ADDENDUM NO.: 1

BID NO.: FWC 18/19-98C

BID TITLE: **F BUILDING (REROOF)**

UPDATE: QUESTIONS AND ANSWERS

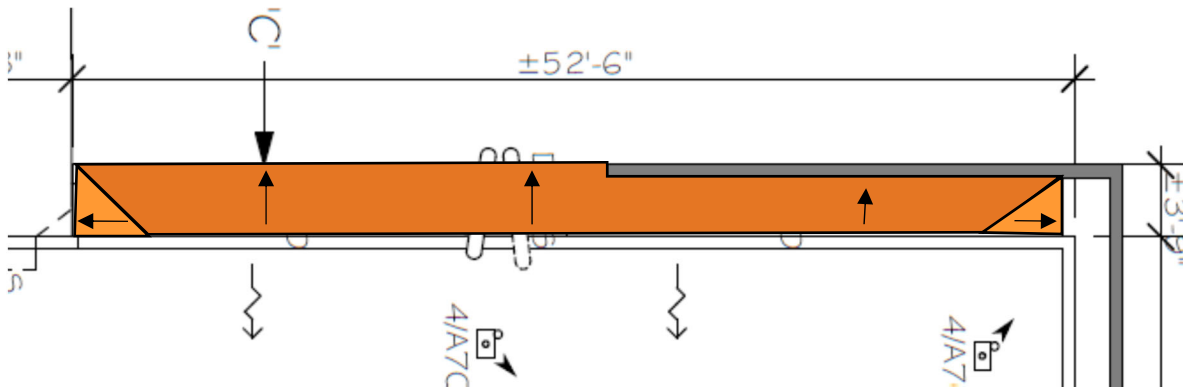
Clarify/ verify requirement for new conduit & wiring from junction to connector point (Note 3)

If raising a piece of roof top equipment is necessary to meet the minimum flashing height requirement, the contractor shall extend the existing conduit and conductors properly to accommodate the equipment being raised. Install new waterproof conduit and correctly sized conductor from nearest junction box to allow for the extension.

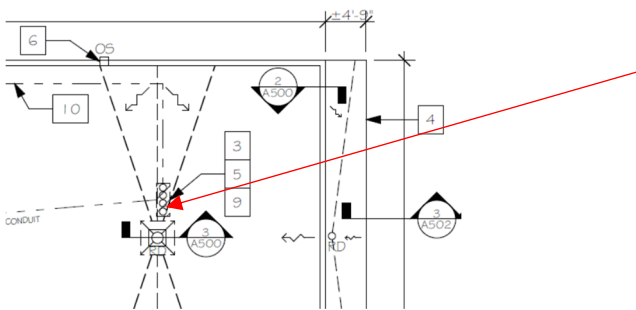
Provide location for Detail/ A502 if applicable.

Not enough information in the question. ____/A502. The assumption is Detail 1/A502. This detail is located in the conduit bank on Roof A. See below...
